1511 DEXTER AVE N.

DESIGN RECOMMENDATION MEETING

DPD PROJECT #3015682
(WEST DESIGN REVIEW BOARD)

NOVEMBER 18 2015

BUILDING ELEVATIONS
NORTH FACADE

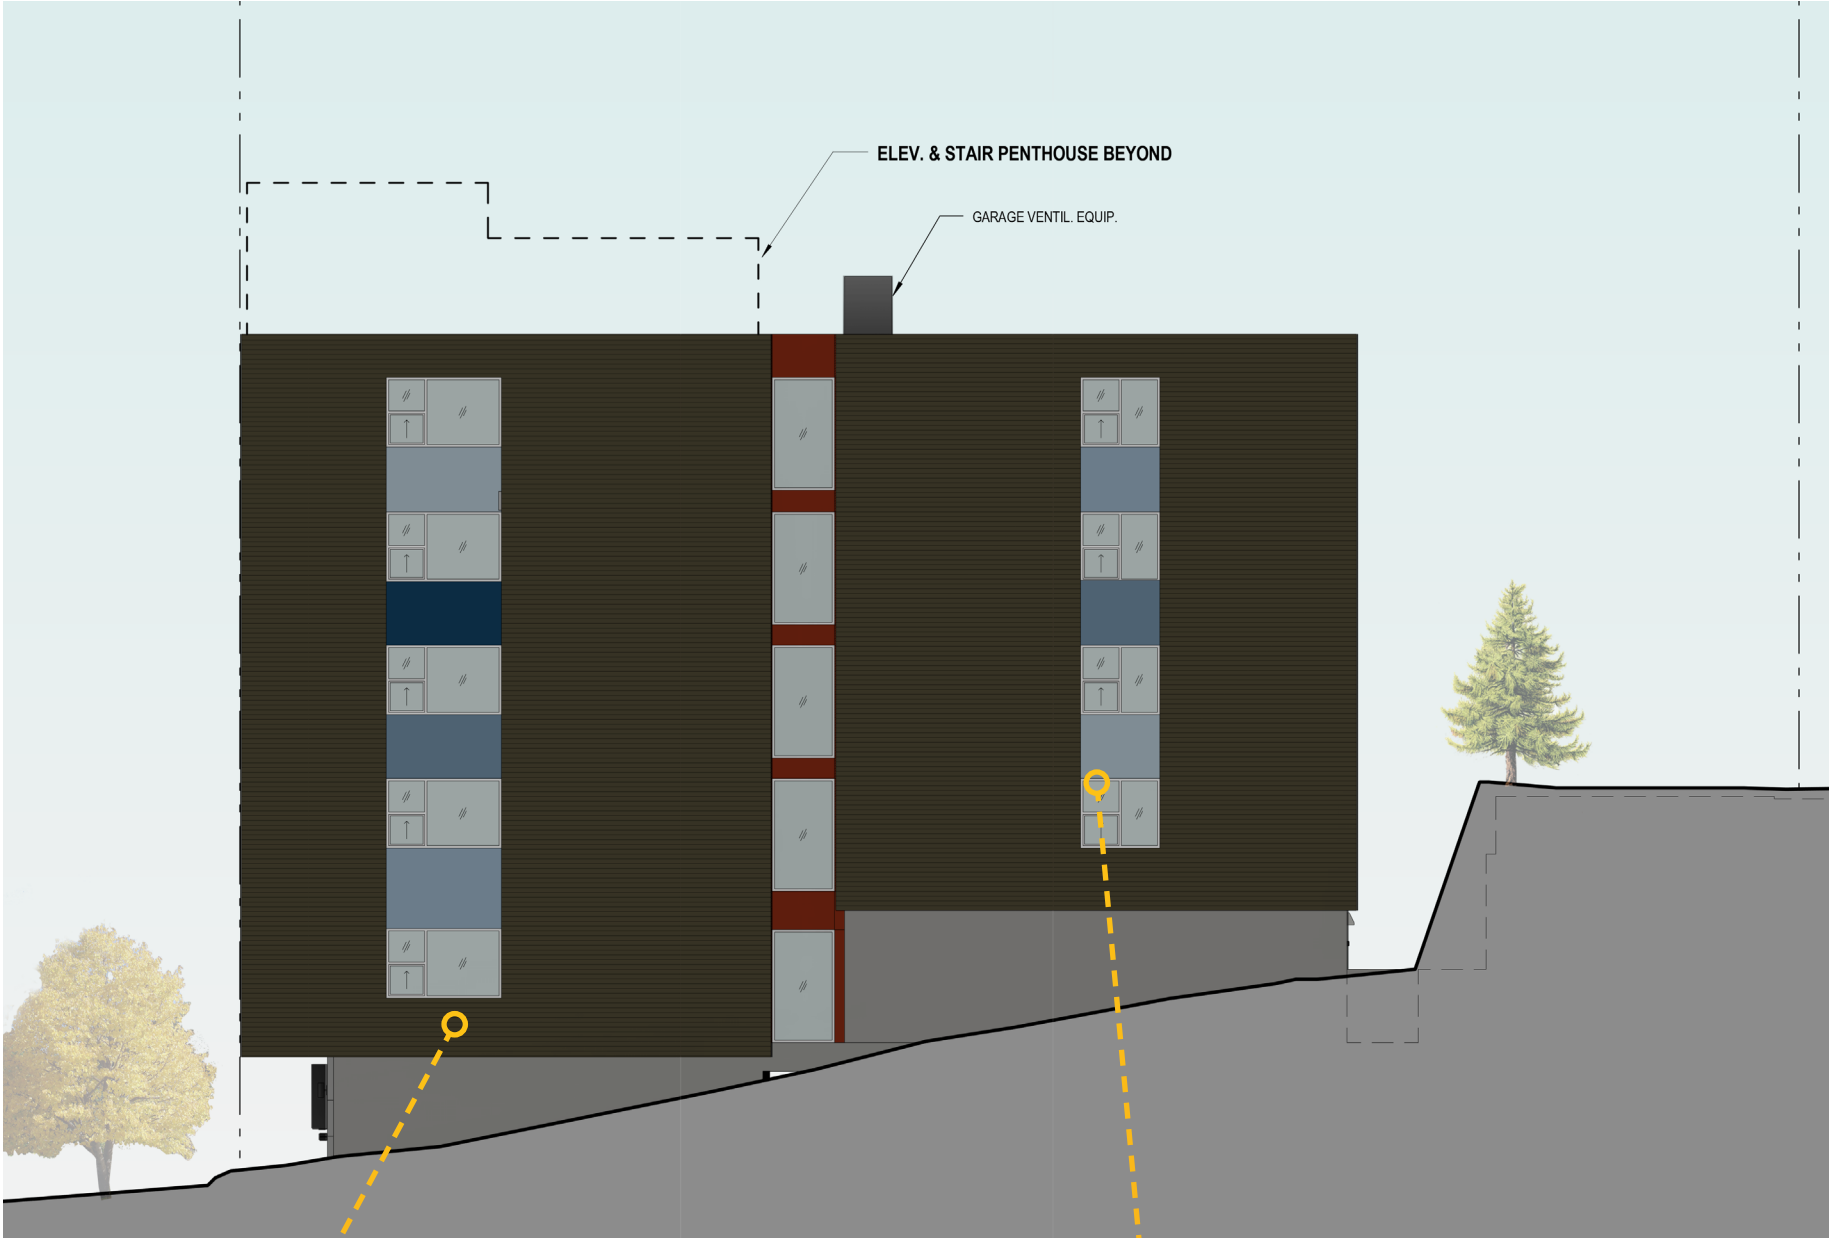
At the Early Design Guidance Meeting, the Board was accepting of the short blank west wall along Galer, assuming it will receive a treatment that provides pedestrian interest. The Board agreed a similar treatment is needed on the north facade corner exit wall, since it will likely be visible for the foreseeable future. The Board supported additional windows, reveals and material variation on the north façade.

On Galer Street, green screen is incorporated into the landscaping to provide additional pedestrian interest. On the north façade wall, the building is pulled back from the property line to incorporate windows and material variation consistent with the south façade.

D-2 - - - - -
BUILDING IS PULLED BACK FROM THE
PROPERTY LINE TO INCORPORATE
WINDOWS AND MATERIAL VARIATION
CONSISTENT WITH THE SOUTH FACADE
(GALER STREET)

VIGNETTE
VIEW FROM PEDESTRIAN BRIDGE

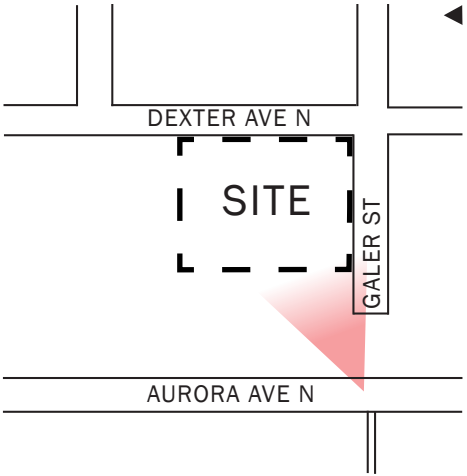
At the Early Design Guidance Meeting, the Board applauded the vehicle access off Galer Street and the alley, not Dexter Avenue which is a primary bike and bus transit street. The Board endorsed the approximate 7 foot setback at the two live work units on Dexter, and the transparent lobby defining the southeast property corner. See A-8 for comments on how the Galer Street parking drive interacts with the streetscape.

A-2
PRIMARY ENTRANCE FACES THE
PRIMARY ARTERIAL (DEXTER AVE N.) AND
VEHICLE ENTRANCE IS OFF OF GALER
ST. TO PRESERVE AS MUCH DEXTER ST.
FRONTAGE AS POSSIBLE FOR HUMAN
ACTIVITY. HIGHLY TRANSPARENT LOBBY
FACES DEXTER AVE N.

VIGNETTE
GALER SIDEWALK VIEW LOOKING EAST

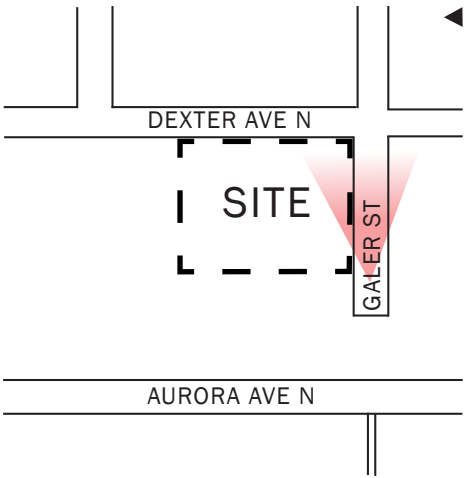
At the Early Design Guidance Meeting, the Board did not emphasize this as a priority guideline, but supported the level 6 amenity deck and its associated setback on the south end of the massing, to improve public views eastward from the Galer Street pedestrian walkways. This appropriate setback and other bulk modulation shown on pg 37 are why Guideline B-1: Height, Bulk & Scale, was not cited as a priority.

E-2
ALONG THE WESTERN PORTION OF THE SITE, THE LANDSCAPING HAS BEEN AGGREGATED TOWARDS THE MOUTH OF THE ALLEY, COMPLEMENTARY TO THE EXISTING LANDSCAPING. A ROW OF TREES PROVIDES SCREENING BETWEEN THE PARKING AND THE BUILDING. RETAINING WALLS STEP DOWN ALONG GALER TO PROVIDE RAIN GARDENS AND VISUAL PEDESTRIAN INTEREST, AND THEMATICALLY CONNECTS TO THE GALER PEDESTRIAN CROSSING LANDSCAPING.
